TECHNICAL NOTE: Response to Metrolink Queries in relation to Solar Glare from 2-4 Whitworth Street

Following consultation feedback provided by Transport for Greater Manchester on 13th January 2025, regarding potential solar glare impacts of the proposed development on drivers of Metrolink trams, GIA have prepared the following responses and provided additional information where necessary.

Time of Day (hours)

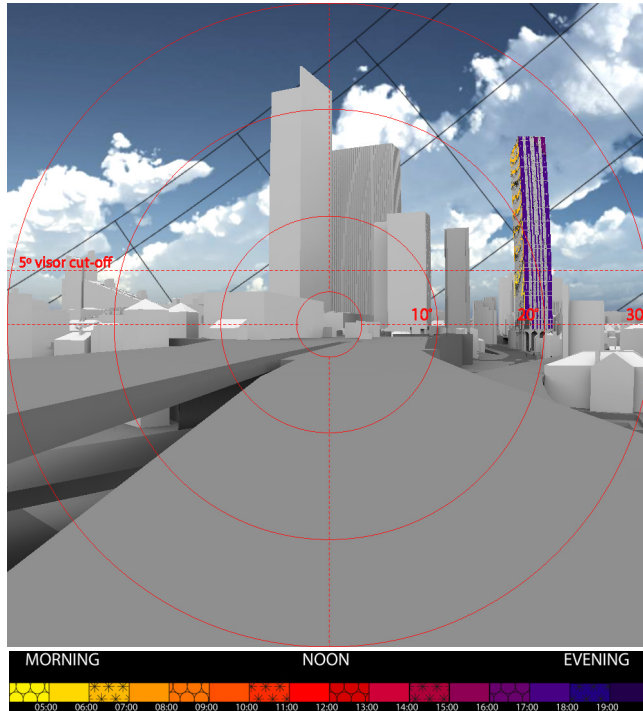
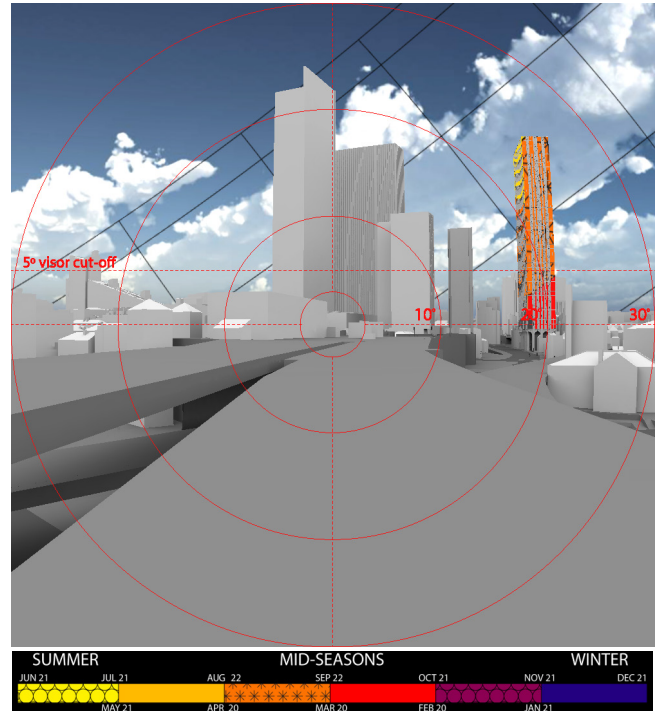
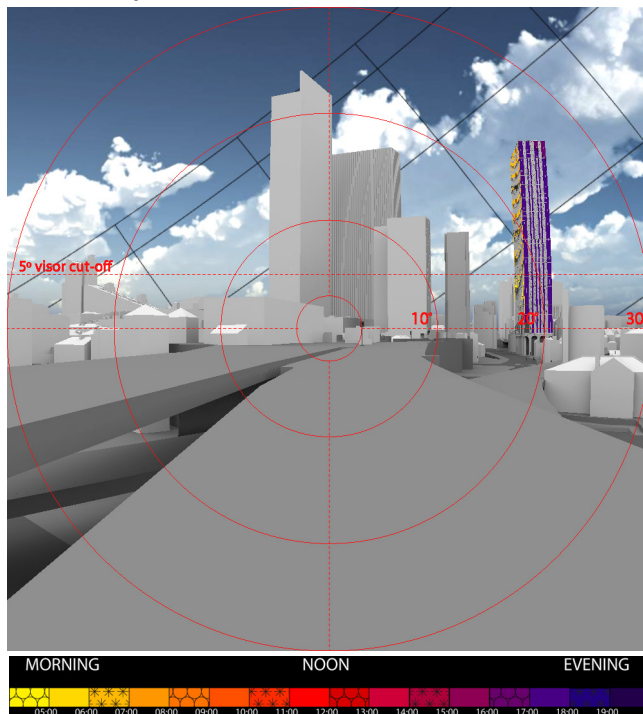
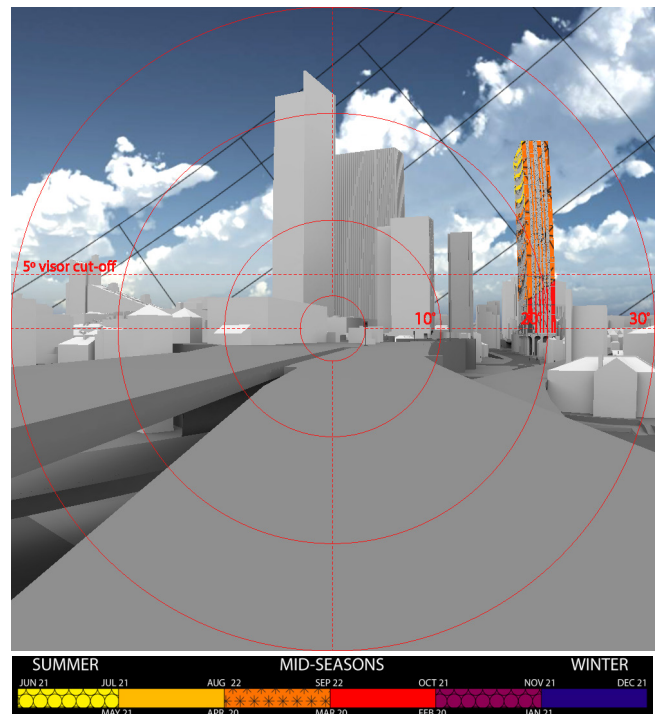
Query 2 - Viewpoint Height

It has been confirmed by TfGM that the viewpoint height is 2.2m not 2m as assessed has been noted. Whilst we do not consider this would alter the effects nor conclusions set out in the ES, for completeness, GIA has update the analysis and provided these results in Appendix 1 alongside those submitted for comparison purposes. The results provided in Appendix 1 confirm there is no noticeable difference between the results of the raised viewpoints at 2.2m compared to the 2m high viewpoints as submitted, therefore the effects and conclusions set out within Chapter 12 of the ES remain unchanged.

PEAK INTENSITY ASSESSMENT
VIEWPOINT TRAM 4 - EASTBOUND TO DEANSGATE-CASTLEFIELD

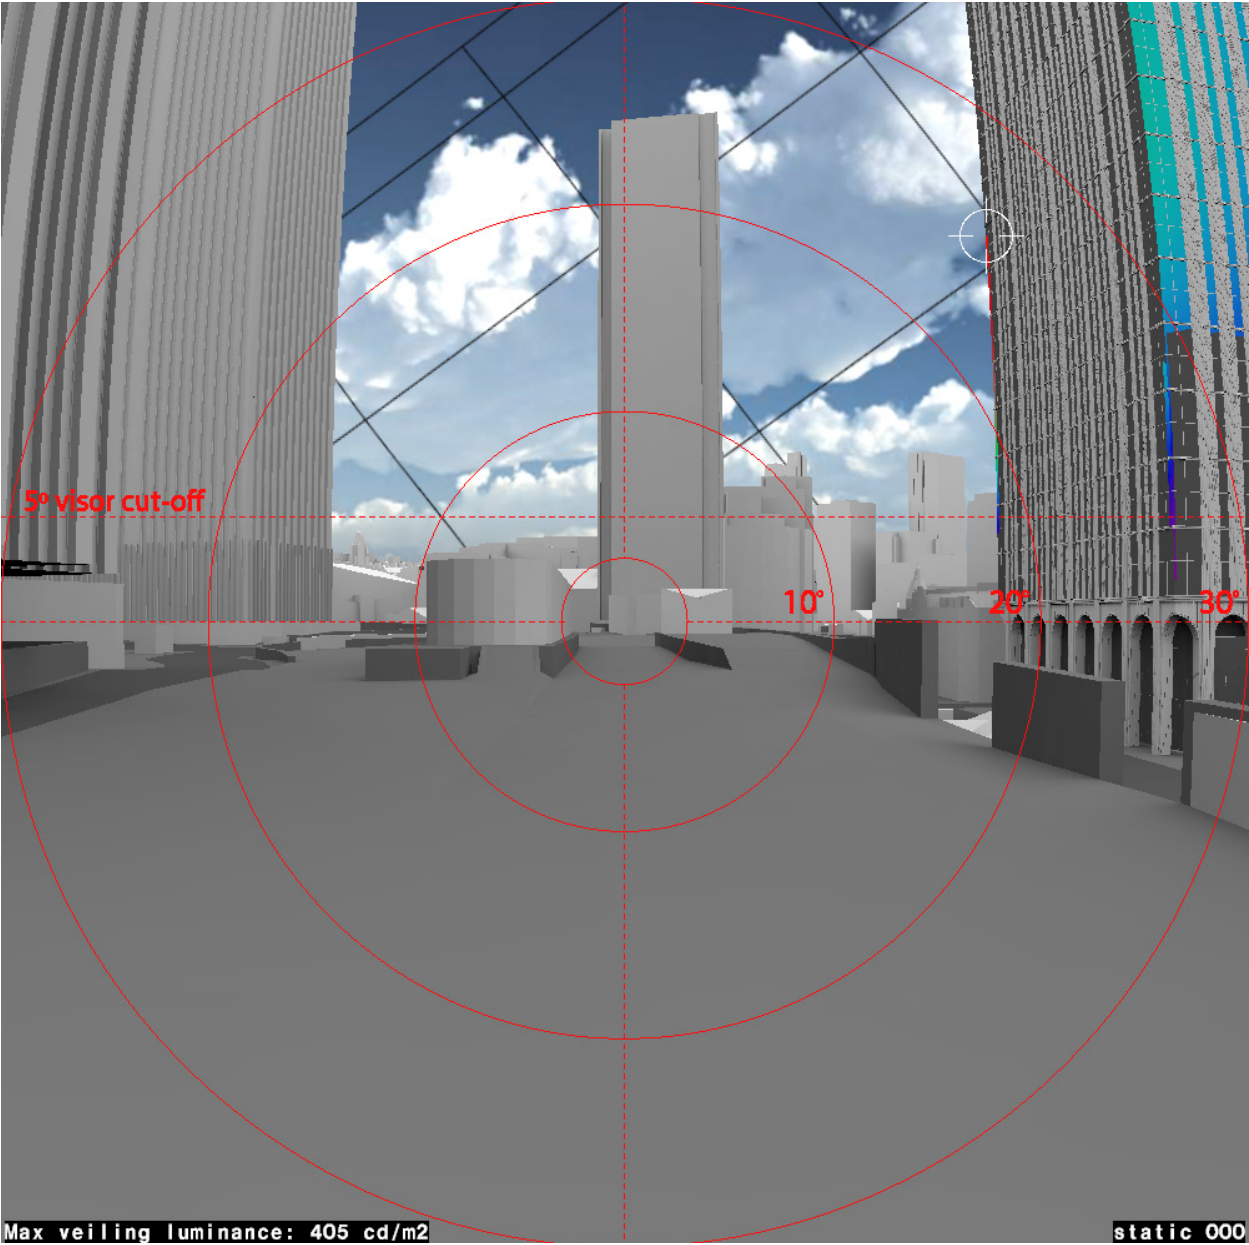
Query 3 - Mitigation Strategies

It has been stated that a professional statement in relation to proposed mitigation strategies is not sufficient and that it must be evidenced that Low VLR glazing would appropriately mitigate the potentially significant effects identified along the eastbound tram line.

Figure 17 shows the peak intensity for viewpoint Tram 4 is 405 cd/m² which is below the threshold for glare of 500cd/m².
